SERVICE INFORMATION LETTER**SIL21-04B**

**PENDING
APPROVAL****SUBJECT:** Improved Rocker Cover Gasket, Part No. 668893**PURPOSE:** Announce new part number availability and important installation instructions**COMPLIANCE:** When replacing rocker cover gaskets**MODELS**

**Figure 1. Gasket Comparison****ISSUED**
2021/05/20**REVISED**
2021/08/19**DOC NO** **REVISION**
SIL21-04 B**PAGE**
1 of 2

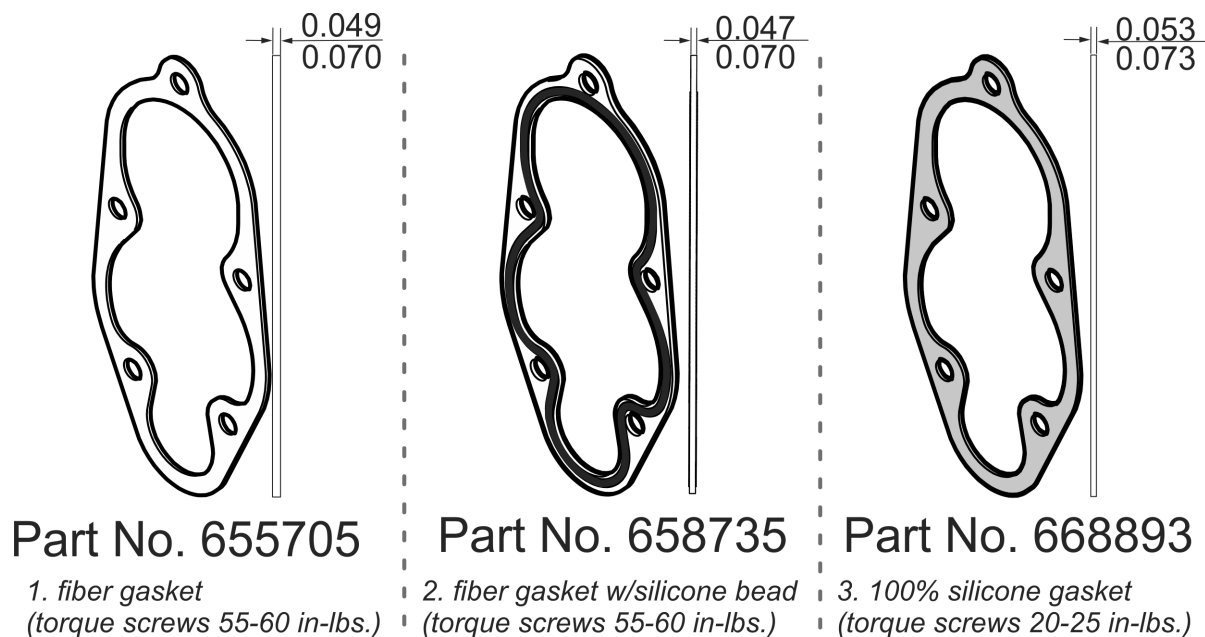
A new silicone rocker cover gasket Part No. 668893 has been placed in production for the crossflow engines listed above. Part No. 668893 gasket supersedes gasket Part No. 658735. The silicone material provides a more flexible seal than the previous gasket, when properly installed.

Rocker Cover Gasket Part No. 668893 is a flexible, silicone gasket, smooth on both sides; no special mating instructions apply. Rocker Cover Gasket Part No. 658735 is a fiber gasket with a silicone bead on both sides of the gasket. Gasket Part No. 655705 (preceded Part No. 658735) and previous gaskets used with crossflow style cylinders were fiber gaskets with no bead. Earlier gaskets were subject to age control; Part No. 668893 is not.

Figure 2. Rocker Cover Installation

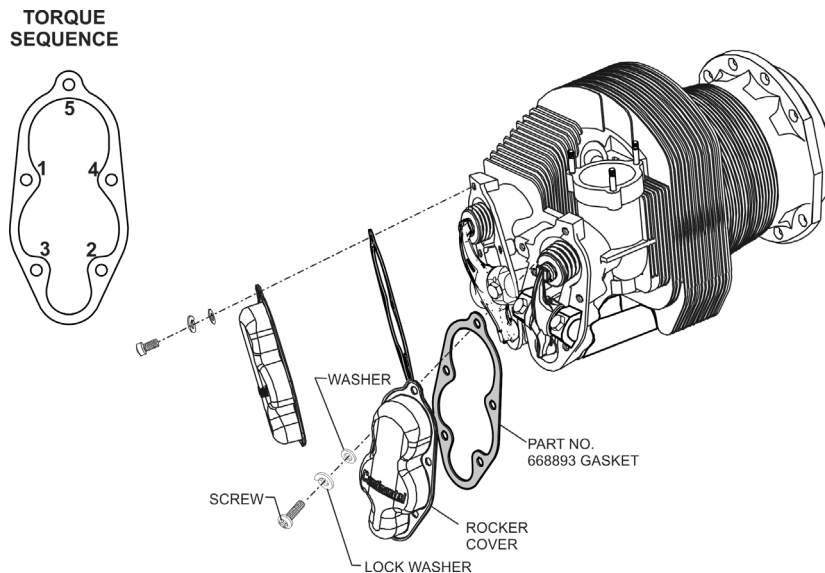
*CAUTION: Failure to clean the rocker and cover flanges will cause leaks. Surfaces must be clean and oil-free to seal properly. Applying 55-65 in-lbs. torque to rocker cover fasteners using Rocker Cover Gasket Part No. 668893 **will damage the gasket and rocker cover.***

1. Clean the rocker box (including threaded screw holes) and cover flanges thoroughly with isopropyl alcohol (IPA) or acetone before installing the gasket to remove oil and old gasket residue. Clean the rocker cover screw threads with a wire brush and rinse with IPA or acetone.
2. Install rocker cover(s) with new gasket according to instructions in the primary ICA.
3. Sparingly apply a thin bead of Continental Part No. 658517 (Loctite® 243) across the rocker cover screw threads according to the manufacturer's instructions. Secure each rocker cover with five screws and torque the screws in an alternating pattern (see Figure 2):

- a. On rockers using gasket Part No. 668893, torque cover screws 20-25 in-lbs.
- b. On rockers using any fiber gasket, torque cover screws 55-60 in-lbs.
